MSO/MST Firmware 2.07.x bug list:

List of bugs/improvement requests

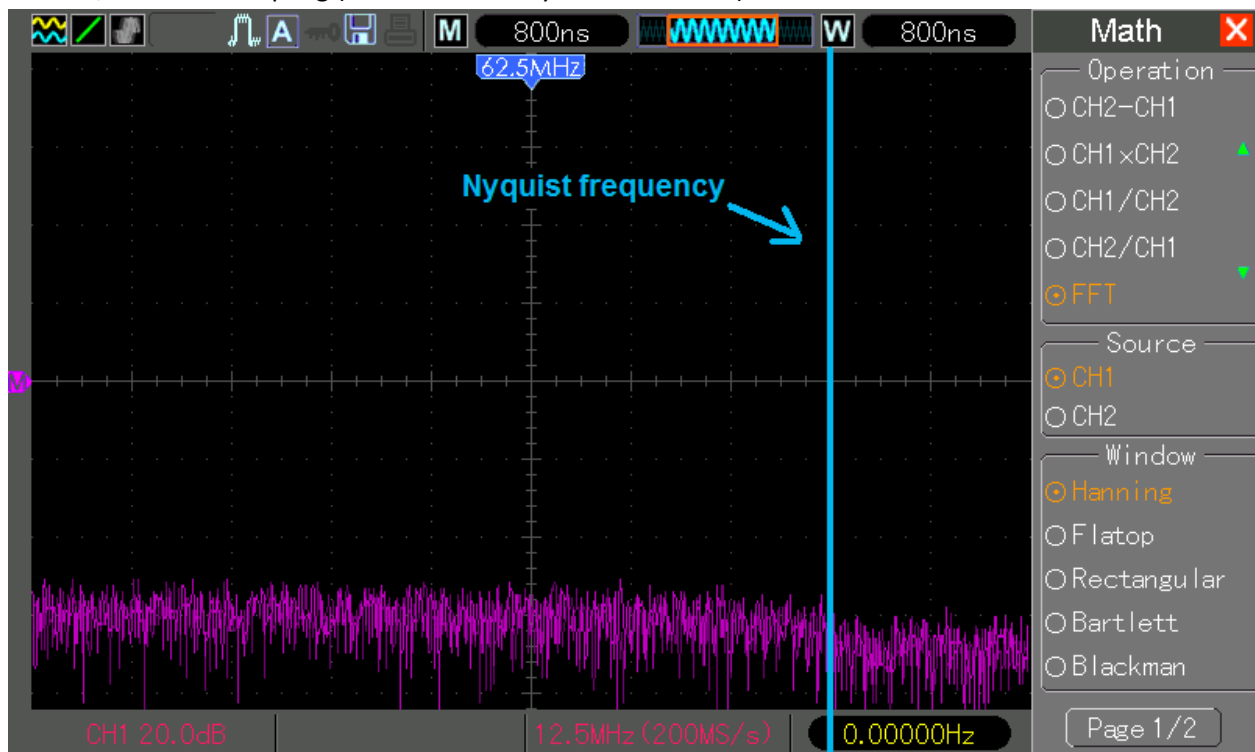
7. In FFT mode when Display -> Grid set to “Real Line” only vertical lines are visible, horizontal lines are missing

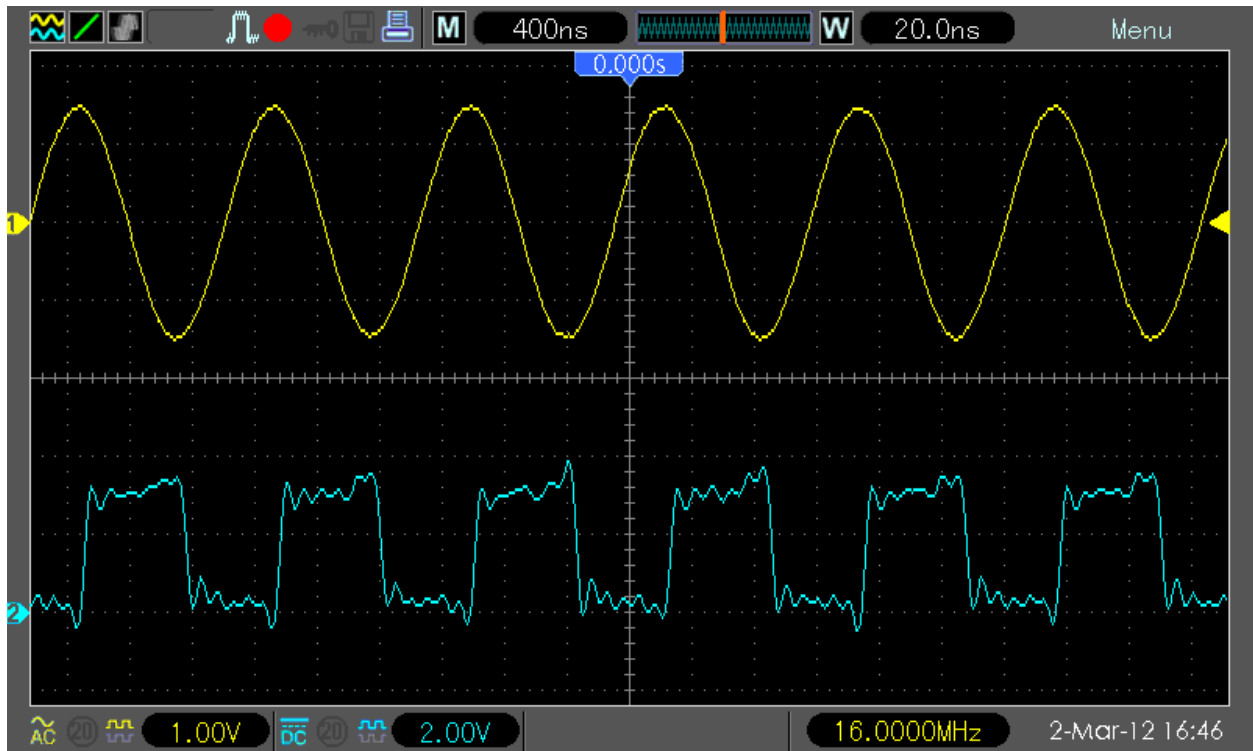
8. In FFT mode “Full span” is higher than Nyquist (sample rate / 2)
Example: 800ns/DIV, sample rate is 200MS/s, full span 125MHz. Easy to fix by enabling from 800ns/DIV to 20ns/DIV 1GS/s sampling (when 4k memory or FFT enabled)

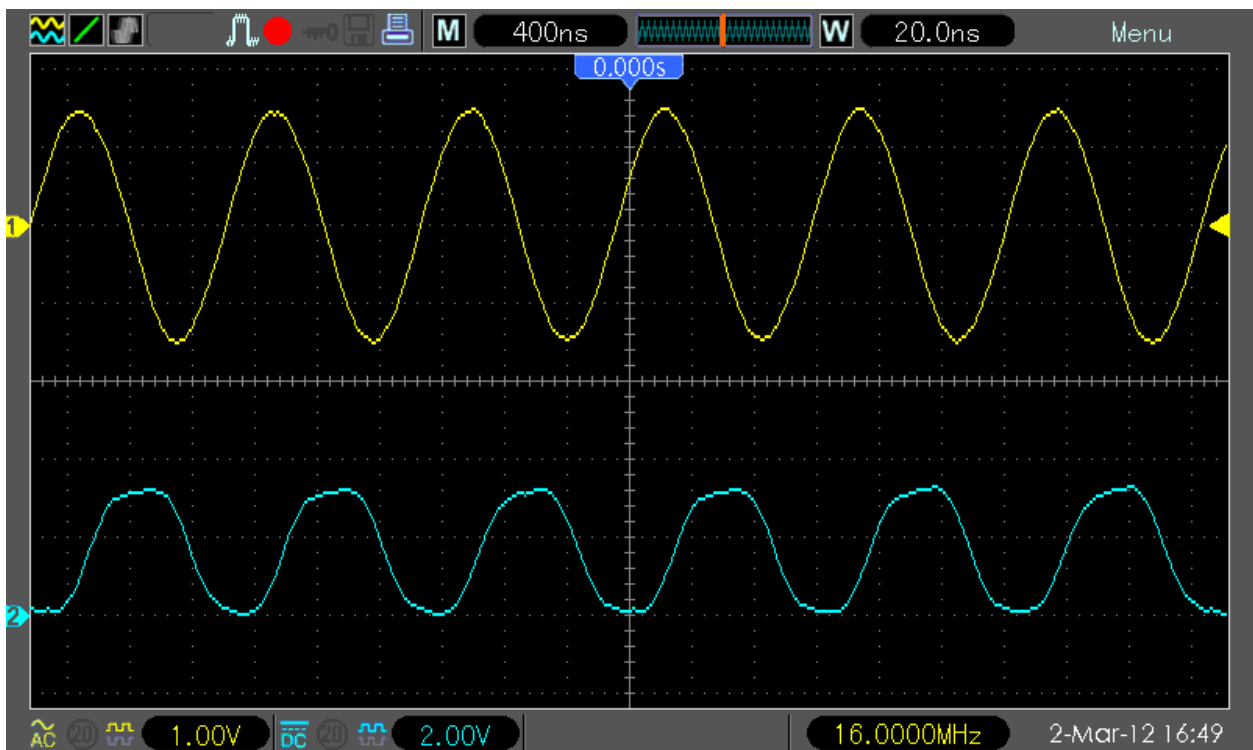
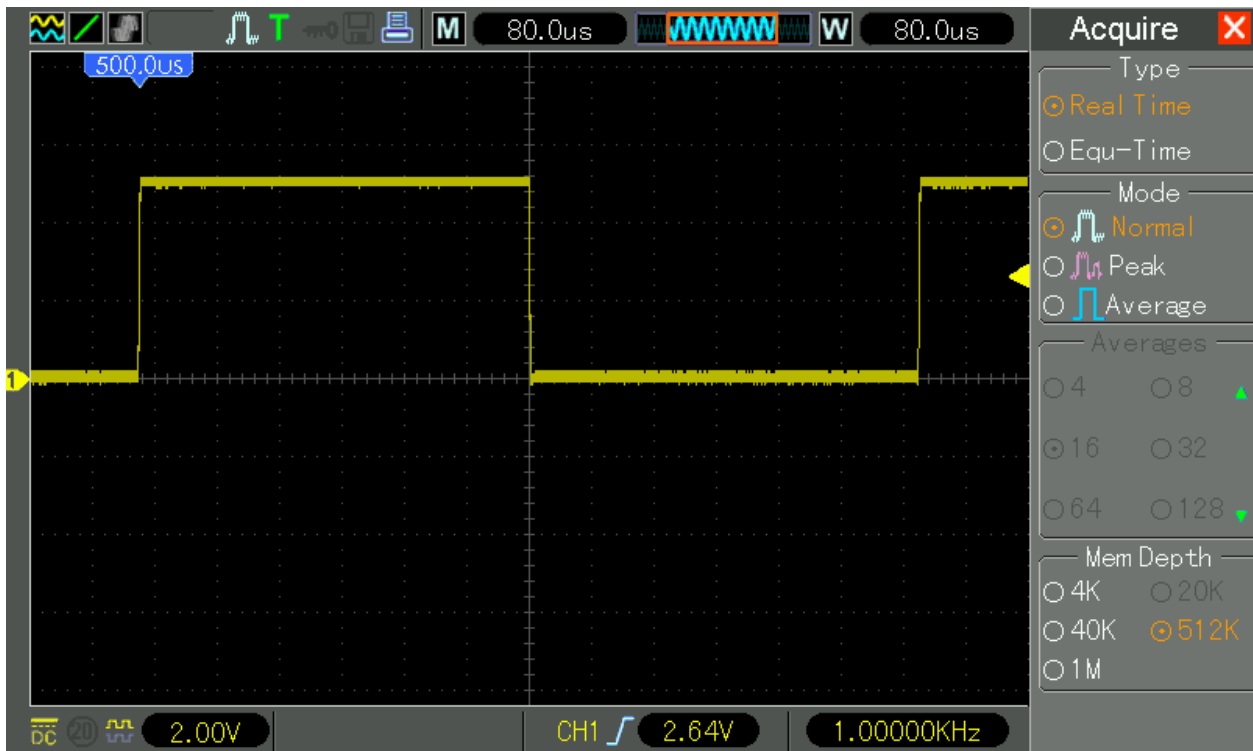
9. Dithering/interpolation filter are too sharp. When enabling both channels (this also occurs in single channel mode and 1GSs, but test signal need to be higher to get same error) and applying for example 16MHz square wave the waveform is switching between proper square:

and crippled square every second:

The best would be to disable (or let user to choose in options) it.

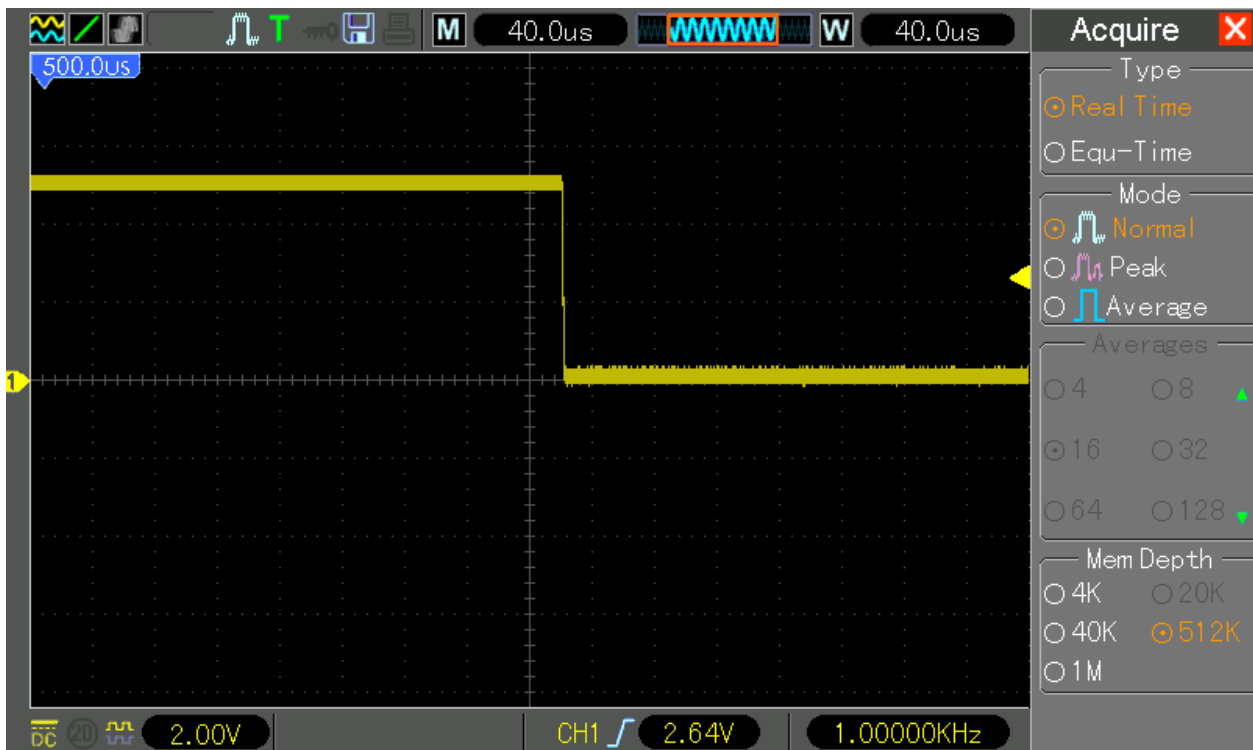
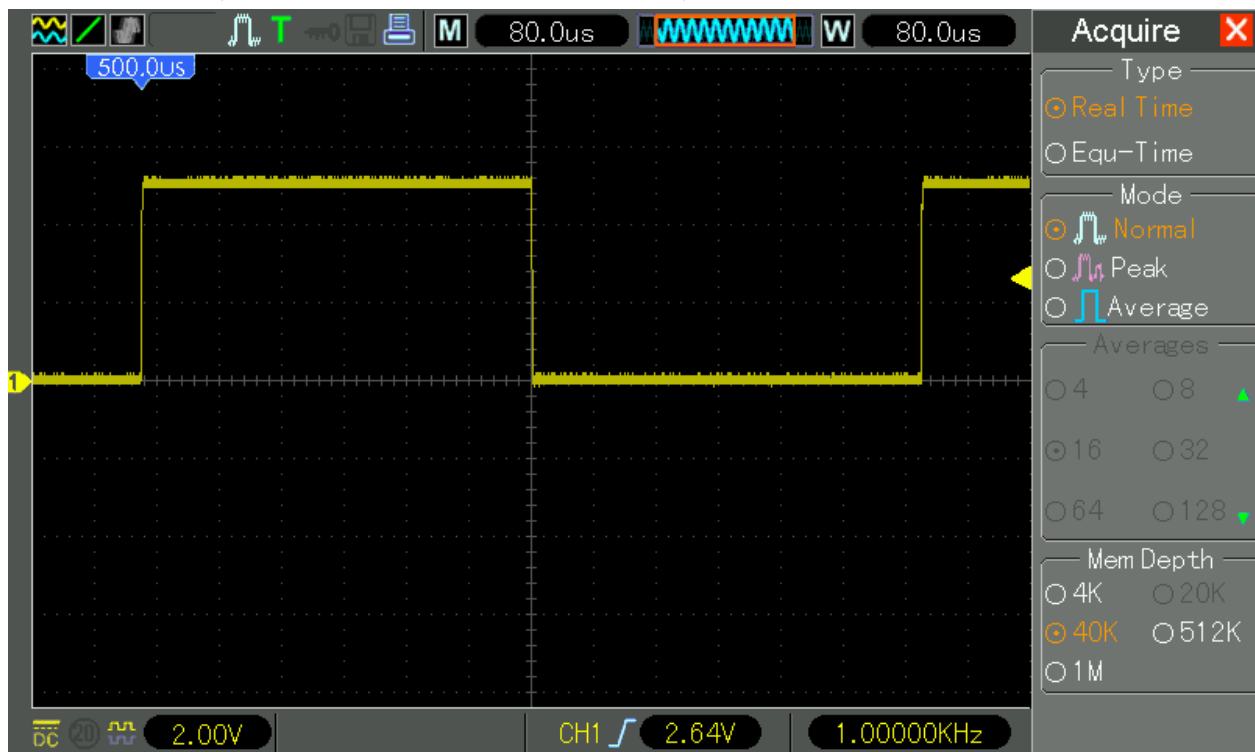
10. Display / Time base scaling strange behavior with 512k memory depth. Apply e.g. 1kHz signal, chose 512k memory depth, set time base to 80us/DIV and move the waveform to 500us/DIV:

When you now change time base to 40uS/DIV the falling edge (which should be still in the middle of the screen) has been moved to 522uS position (but it should stay on 500uS). The same happens of course with 20uS/DIV, etc):

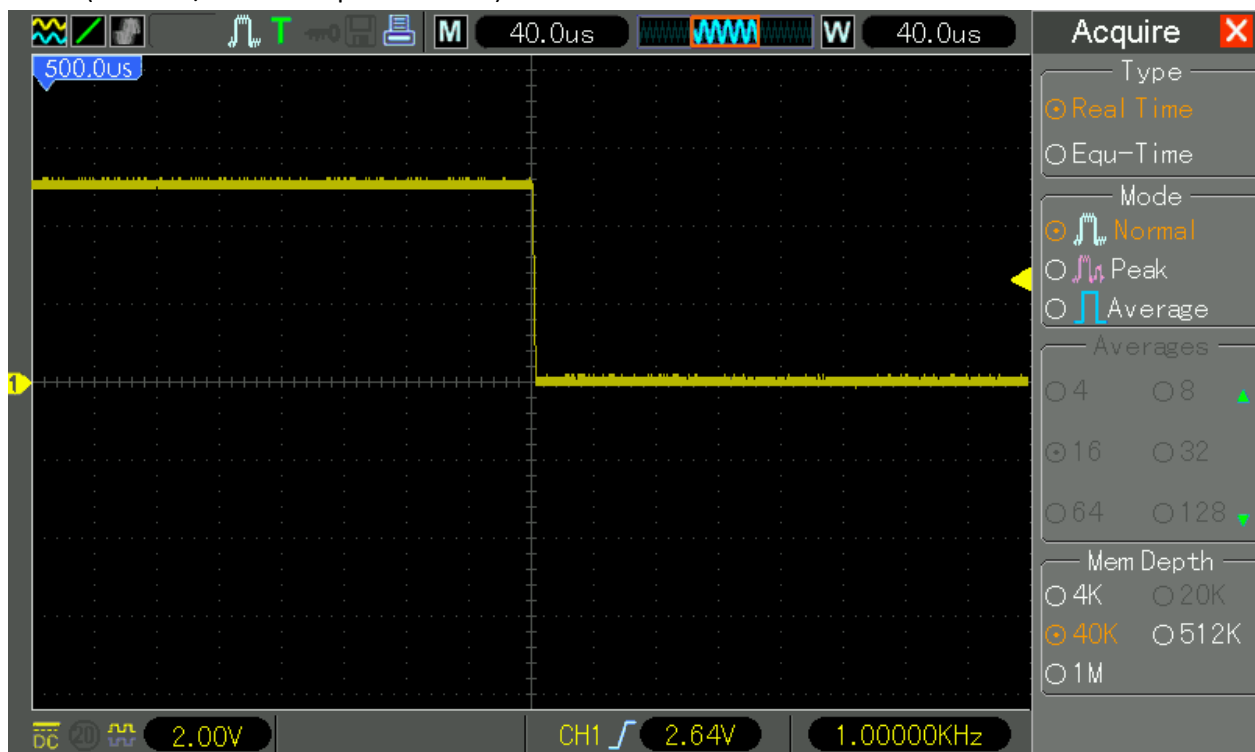
11. Missing Waveform refresh with 40k memory depth. Apply e.g. 1kHz signal, chose 40k memory depth, set time base to 80us/DIV and move the waveform to 500us/DIV:

When you now change time base to 40us/DIV the falling edge is in the middle of the screen (not like in similar 512k bug), but the waveform is completely static – no refresh, as if the DSO would be in STOP mode (but RUN/STOP is on position RUN):

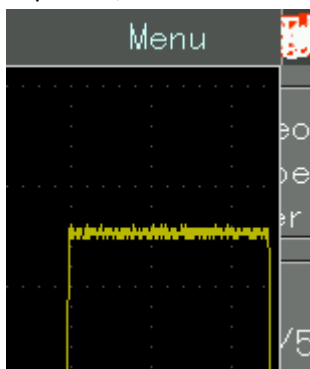
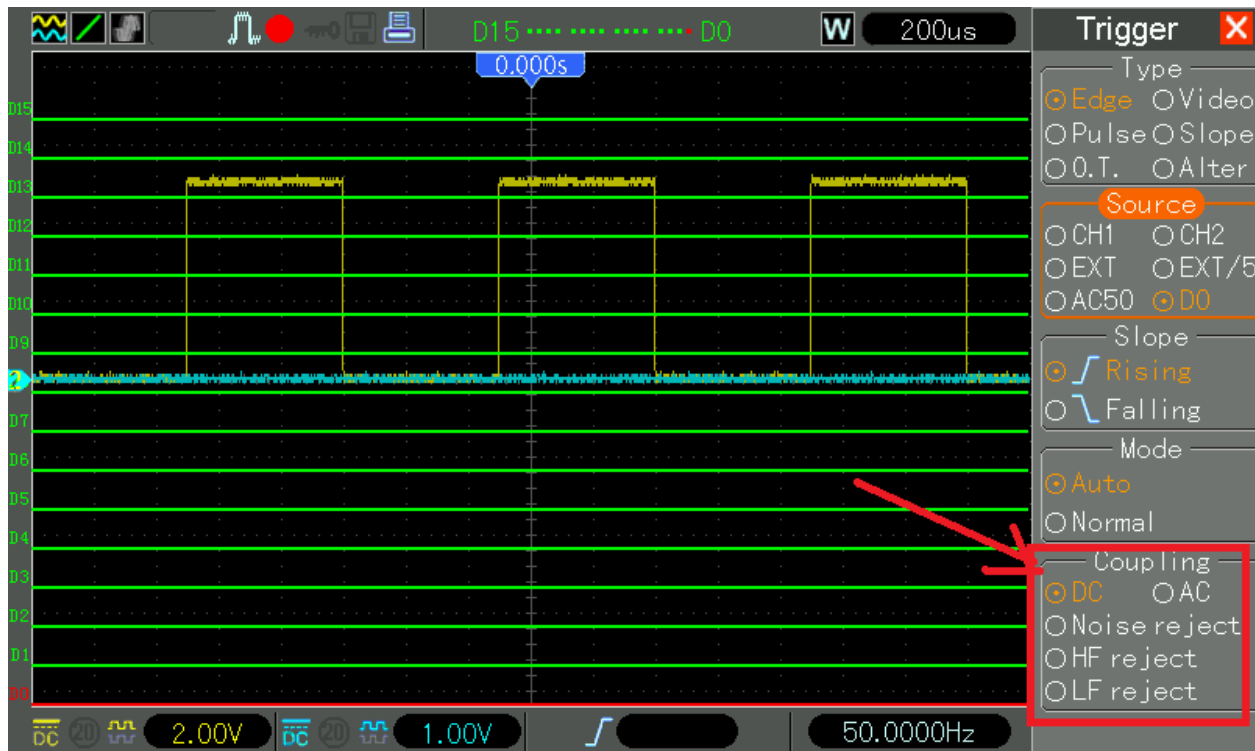
21. When in LA mode and LA menu selected off, the next push of button F7 brings normal DSO screen, as expected, but remains of a previously selected menu are visible in the right-hand edge of the screen:

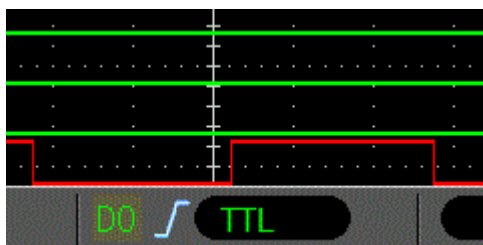
24. Horizontal Position knob not moving display data. Set Trigger to "Normal" – when MSO not triggered the waveform/horizontal screen position cannot be changed. Once triggered it changing rapidly. Another example – set trigger to Single Sequence and Auto , while trigger in "R" (ready) mode waveform/horizontal screen position cannot be moved. Again, once triggered it change rapidly. **In DSO firmware 110923.1 this was working :**

but in the MSO is not working (same condition, Horizontal position knob already turned few times but no move on screen):

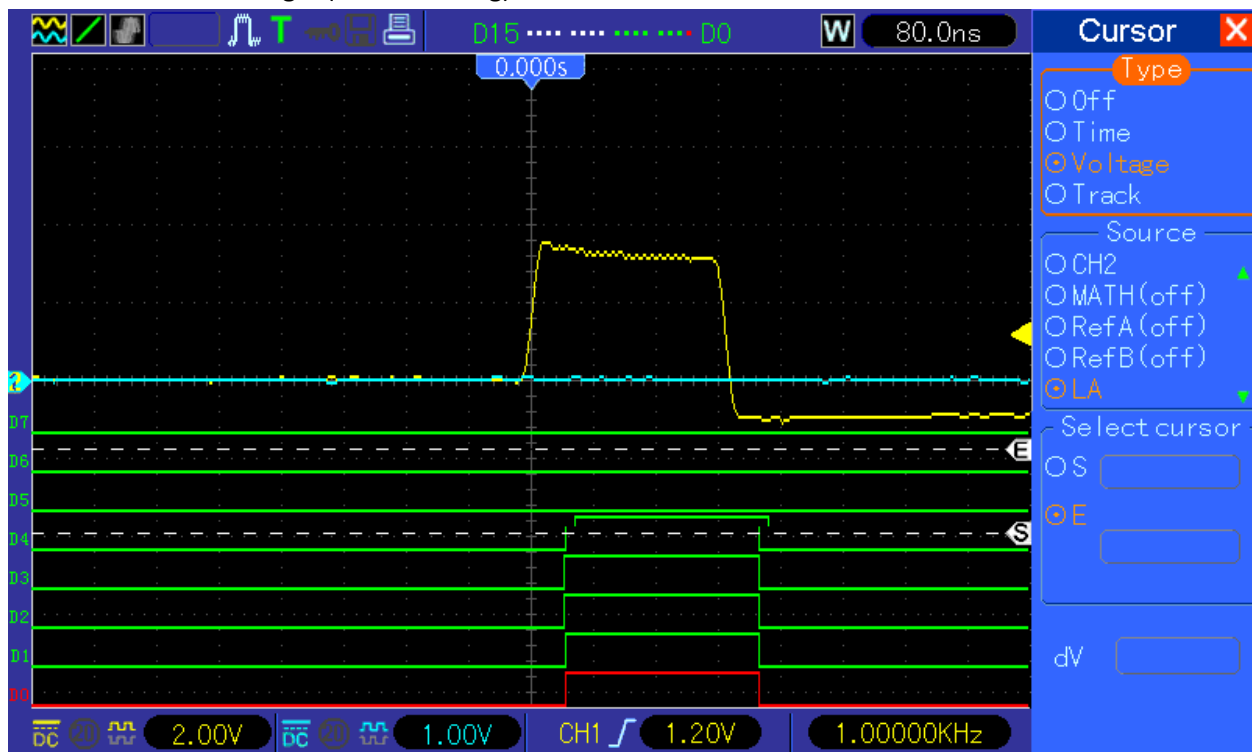
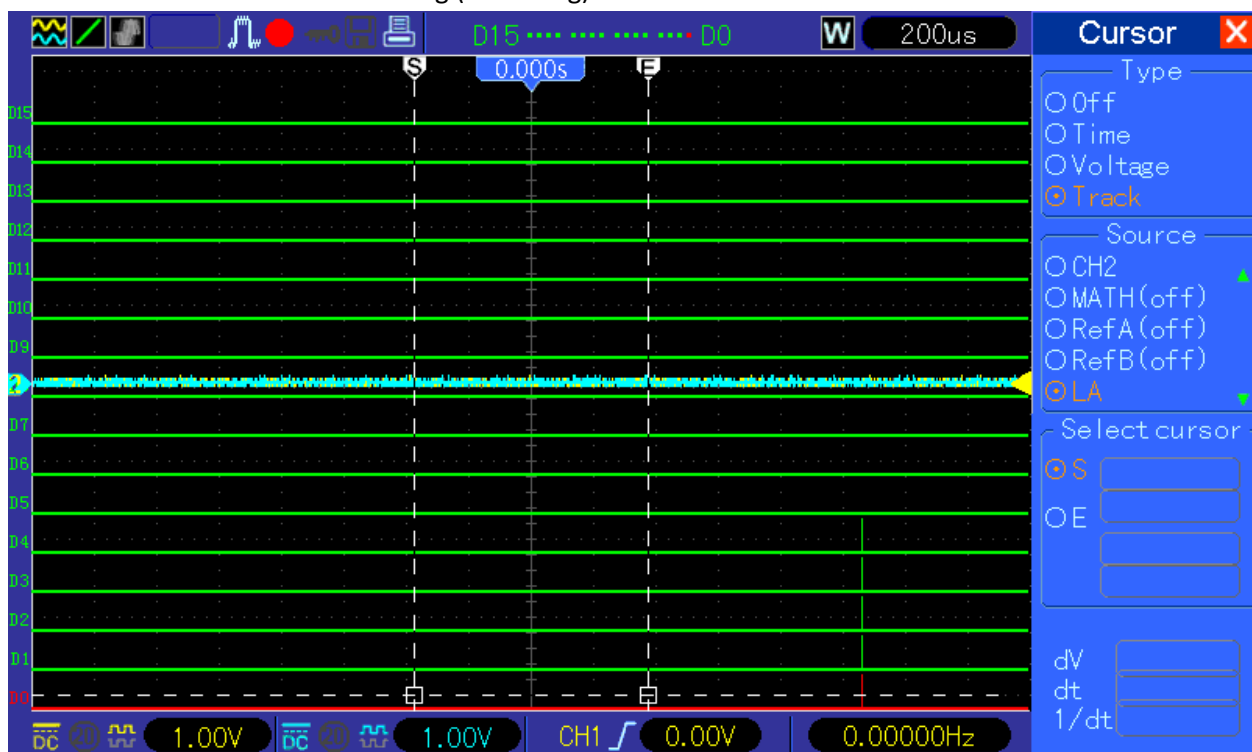
32. Voltage Cursor error: It is possible to choose Voltage Cursor for LA, which is useless/bug
Directly the firmware is blocking to select LA as source for Voltage Cursor (which is like it should be),

but when I select first Time Cursor, select LA as Source and the change Cursor type from Time to Voltage the firmware is allowing it (which is a bug):
